The redline revisions shown on this drawing represent all of the changes that have been made since the August 2023 Aggregate Resource Act site plan

Caledon Pit & Quarry

18722 Main Street, Caledon, Ontario

Technical Recommendations

Noise Mitigation Schematic

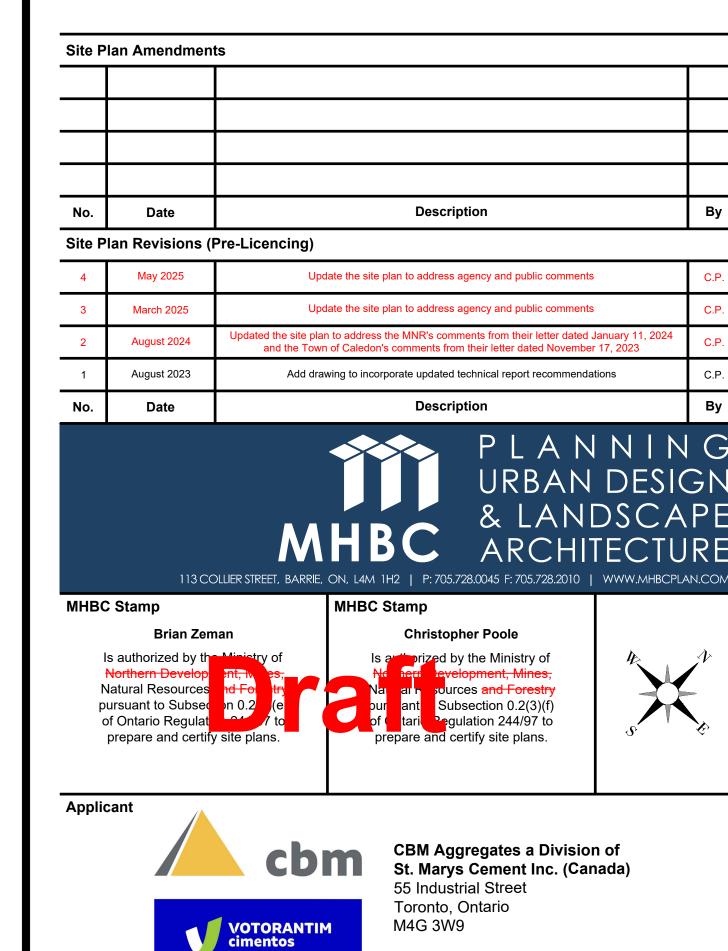
Drills procured for the Site operations shall be mitigated (e.g., manufacturer installed noise controls) resulting in a sound power level of 116 dBA. In addition, when operating within the identified areas on the Noise Mitigation Schematic on this drawing or drawing 2 of 4, the drills shall be equipped with a 4.5 m high "C - shaped" and 22 m long local barriers located at the distance of 5 m from the equipment (or acoustically equivalent). In addition, operational restriction shall be considered for drills operating in specifics areas as indicated on the Noise Mitigation Schematic on this drawing or drawing 2 of 4 Area 1 - operation of a single unmitigated drill; Area 2 - operation of a single mitigated drill;

Area 3 - operation of two mitigated drills; and, Area 4 - operation of one mitigated and one unmitigated dril k. The number of extraction loaders shall be reduced from three to two units when equipment operates in the areas identified as

Area 5 through Area 6 and shown on the Noise Mitigation Schematic on this drawing or drawing 2 of 4. In addition, the loaders operating in Area 6 shall be similar to the plant loader with sound power levels of 107 dBA. I. Gravel extraction shall be completed using a single loader with a sound power level of 107 dBA.
